Product Change Notice

Sub: Dimensional changes

Part series: EBW series, EBWA and EBWB

Effective Date: May 1st 2018

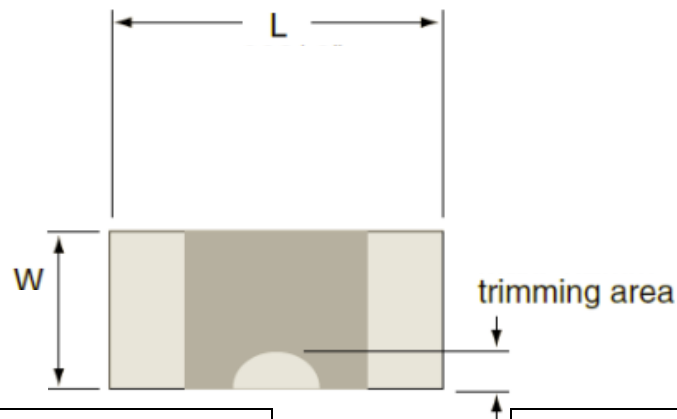
Effective May 1st the Ohmite Manufacturing EBW series will carry a different set of dimensions. The new dimensions have no effect on the product form, fit, or function. The EBW series will still use the same PCB land pattern. Old and New Dimensions are listed below for convenience. All products with date codes of 1918 (**19th week 20018**) and newer will be produced with the new dimensions.

Old Dimensions			
	Ohm Value	L	W
		Tol +0.2 -0.0	± 0.3
	Milli ohms	mm	mm
EBWA-M	0.5	10.5	5
EBWA-M	1		
EBWA-N	2		
EBWA-N	3		
EBWA-N	4	15.2	7.5
EBWB-M	0.2		
EBWB-M	0.5		
EBWB-N	1		
EBWB-N	2		
EBWB-N	3

New Dimensions			
	Ohm Value	L	W
		Tol +0.3 -0.2	Tol +0.3 -0.2
	Milli ohms	mm	mm
EBWA-M	0.5	10	5.2
EBWA-M	1		
EBWA-N	2		
EBWA-N	3		
EBWA-N	4

Tol ± 0.2	Tol +0.3 -0.2
EBWB-M	0.2	15.2	7.75
EBWB-M	0.5		
EBWB-N	1		
EBWB-N	2		
EBWB-N	3
